Access Compliance Report

Public Rights-of-Way

Intersection ID: 18664	Main Street: PHOENIX_PL	Cross Street: SHARON_LN	Location: NW
ADA ID: A4E03DD14AD0	Ramp Type: PerpDiag	Initial Pass/Fail: Fail	Overall Compliance: No
		Severity Score: 12.5

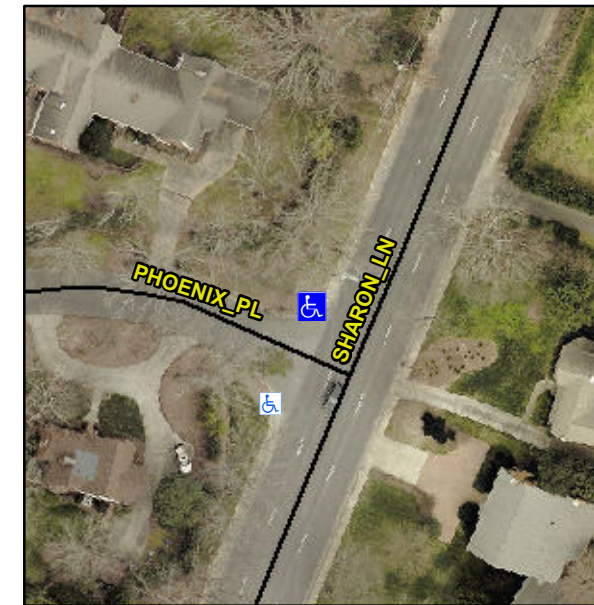
Not Found, R304.5.3

Compliance	Description	Data	Compliance	Description	Data
N/A	Ramp Length (in)	60.0	Yes	Ramp Slope (%)	5.7
Yes	Ramp Width (in)	48.0	No	Ramp XSlope (%)	5.2
N/A	Flare Type LT	N/A	N/A	Flare Type RT	N/A
N/A	Flare Slope LT (%)	N/A	N/A	Flare Slope RT (%)	N/A
N/A	Flare Traversable LT?	N/A	N/A	Flare Traversable RT?	N/A
N/A	Landing Length (in)	N/A	N/A	DWS Provided?	N/A
N/A	Landing Width (in)	N/A	N/A	DWS Contrast?	N/A
N/A	Landing Slope (%)	N/A	N/A	DWS Length (in)	N/A
N/A	Landing X Slope (%)	N/A	N/A	DWS Full Width?	N/A
N/A	Landing Curb? (Y/N)	N/A	N/A	DWS Offset (in)	N/A
N/A	Shared Landing?	N/A			
N/A	Gutter Ponding?	N/A	N/A	Gutter Slope (%)	N/A
N/A	Gutter Lip Ht (in)	N/A	N/A	Gutter X Slope (%)	N/A
N/A	Painted X Walk1?	No	N/A	Painted X Walk2?	No
	X Walk 1 Direction	To SW		X Walk 2 Direction	To SE
N/A	X Walk 1 Width (in)	N/A	N/A	X Walk 2 Width (in)	N/A
	X Walk 1 Slope (%)	1.2		X Walk 2 Slope (%)	4.5
	X Walk 1 X Slope (%)	4.9		X Walk 2 X Slope (%)	1.5

Remove & Replace Curb Ramp With Two New Directional Ramps or Equivalent.
